# Access Compliance Report

## Public Rights-of-Way

### (Pedestrian Signals)

Intersection ID: N/A	Main Street:	Cross Street: N/A	Location: N/A
ADA ID: DF7297E0190A	Signal Type: One Push Button-Non APS	Overall Compliance: No	Severity Score: BTN 1: N/A BTN 2: N/A No BTN: N/A
Codes/Mitigation Info/Possible Solution		Field Measurements/Component Compliance

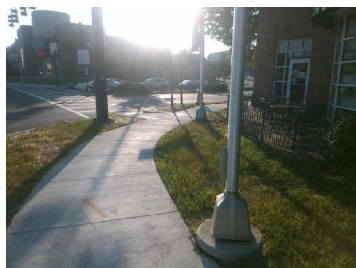
Surveyor Notes: TEXT HT 1/2

PROW/ADA: R410.6, TMUTCD 4e.08, R404.2, R404.3, R404.7.3

Possible Solutions: Replace Signal Push Button With APS Button on New Post. Remove & Replace Sign.
